3rd Further Information

Temporary Open Storage of Construction Materials and Machineries with Ancillary Facilities for a Period of 3 Years and Associated Filling of Land in "Residential (Group D)" Zone,

<u>Lot 55 (Part) in D.D. 108, Pat Heung, Yuen Long, New Territories</u>

(S.16 Planning Application No. A/YL-PH/974)

PHOTO1: EXISTING WATERCOURSE CONDITION

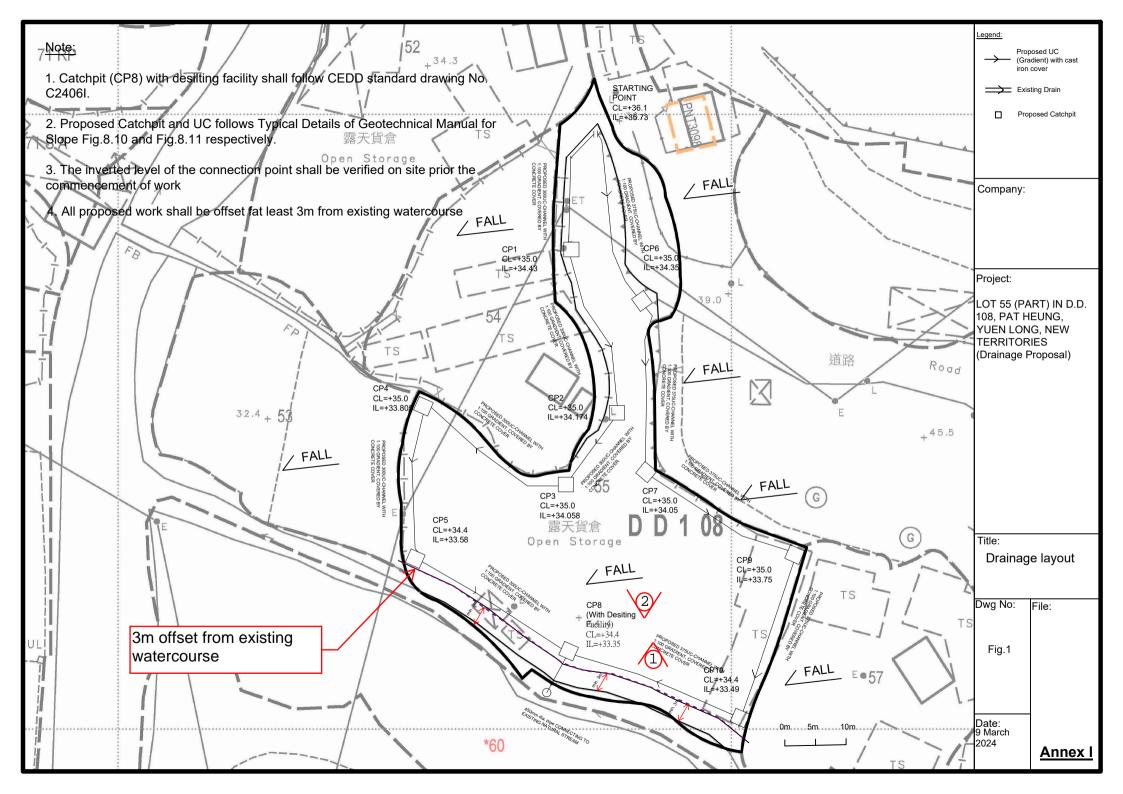
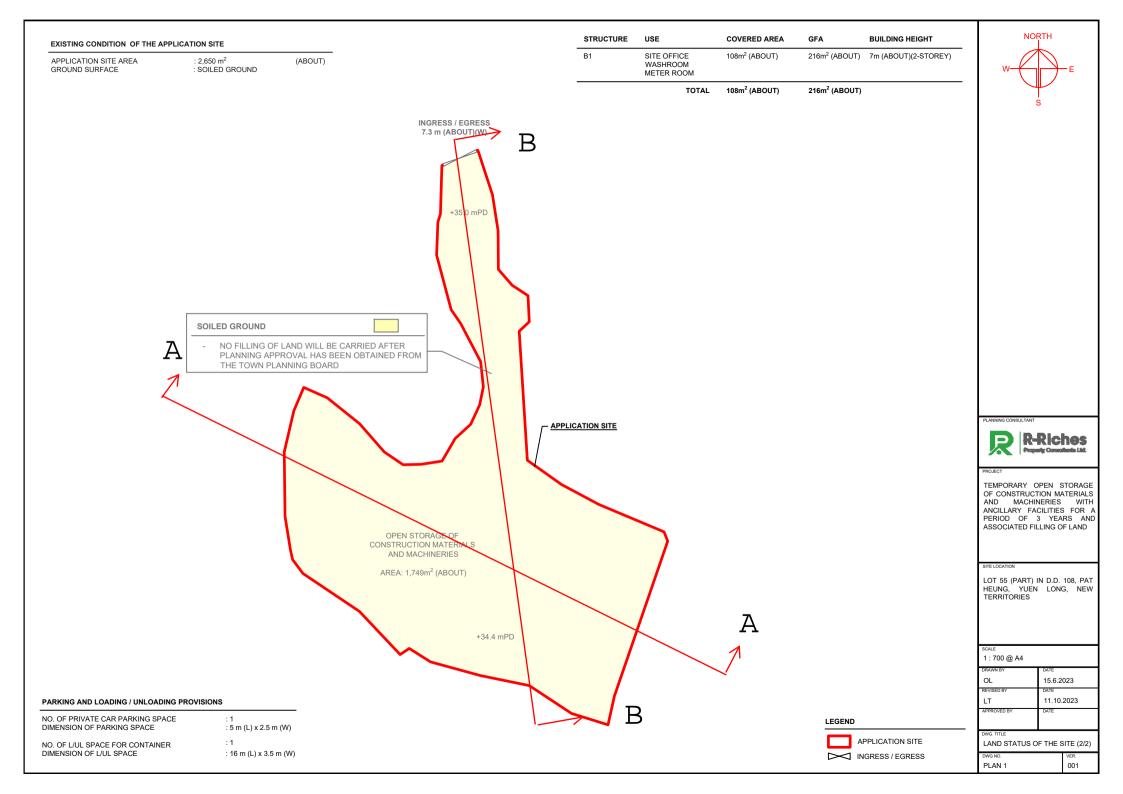
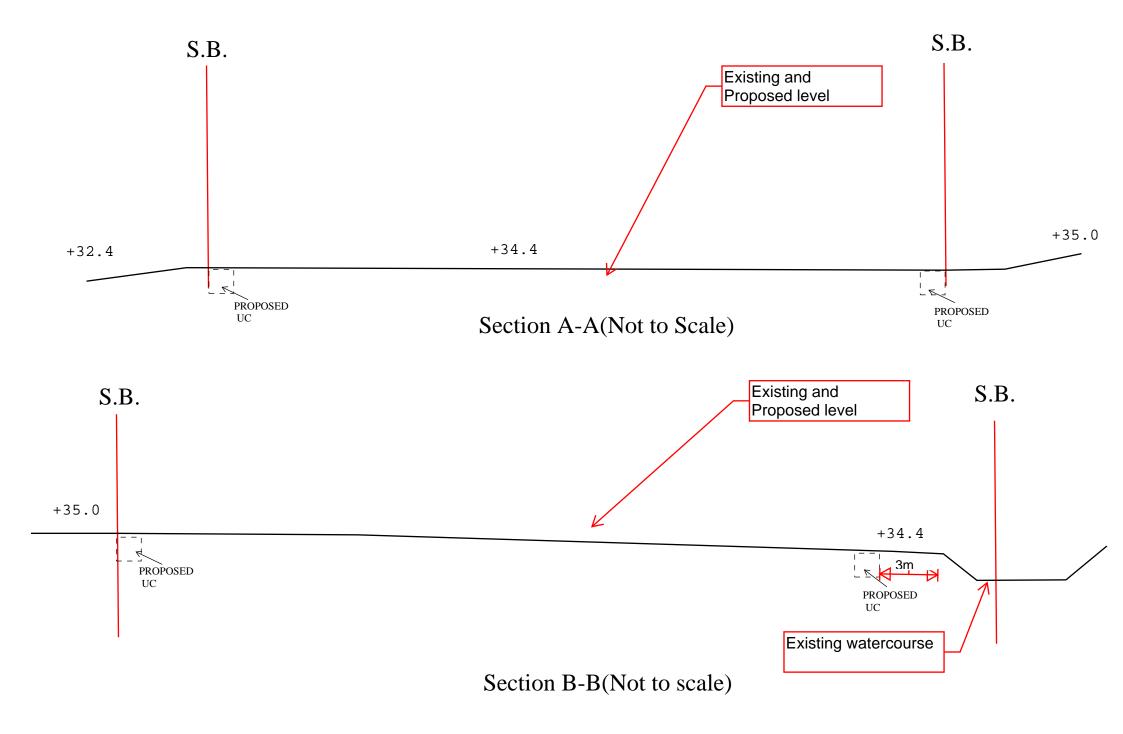
(c)	Plan 4: The 25m and 3m setback ratio is obviously not correct. Please revise.	It is revised accordingly.				
(d)	Photo 13: The stock should not be placed adjacent to the existing watercourse within 3 m distance. Please retake photo for record.	Photos were retaken for your reference.
